Sub.: Regarding comment/Suggestion on Draft MS No. RDSO/2025/EL/MS/xxx (Rev. '0') for provision of 3-pole 80A compact-type electromagnetic contactors in place of conventional electromagnetic contactors in EMC panels for WAP4 and WAG7 locomotives, based on condition assessment.

Modification Sheet No. RDSO/2025/EL/MS/xxx (Rev. '0') dated xx/xx/2025.**1.0 Title:**

The provision of 3-pole 80A compact-type electromagnetic contactors in place of conventional electromagnetic contactors in EMC panels for WAP4 and WAG7 locomotives, based on condition assessment.

4.0 Existing and modified arrangement:

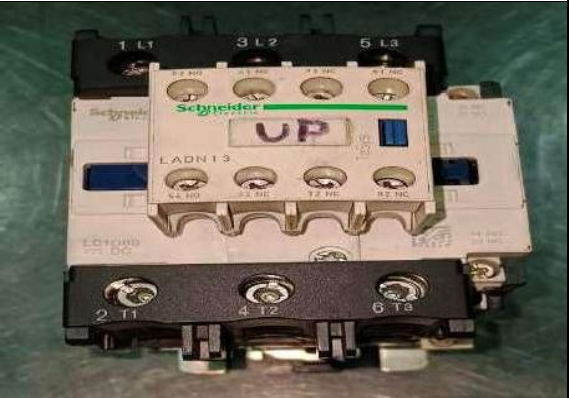
Conventional type EM Contactor	Compact type EM contactor

Existing TK Panel	Modified Panel

1. Unload the conventional-type contactor from the TK panel.
2. Remove the contactor's holding clamp. Disconnect the incoming, outgoing, and control cables.
3. Take two pieces of Hylam/SRBGF sheet with dimensions of 75 cm x 15 cm x 10 mm.
4. Drill holes in the Hylam bars according to the hole positions on the base of the contactor for proper fitment.
5. Drill additional holes in the Hylam bars for mounting them onto the TK panel channel.
6. Fit the Hylam bars into the TK panel channel, ensuring proper spacing between them to accommodate the contactor.
7. Mount the compact contactor (Type LC1D80) onto the Hylam bars inside the TK panel.

8. Adjust the layout of the incoming, outgoing, and LT power cables according to the new contactor position.
9. Replace the lugs of the incoming power cable, outgoing power cable, and LT cable from ring-type lugs to ferrule-type lugs.
10. Install an additional interlock (Type LADN22) in front of the contactor.
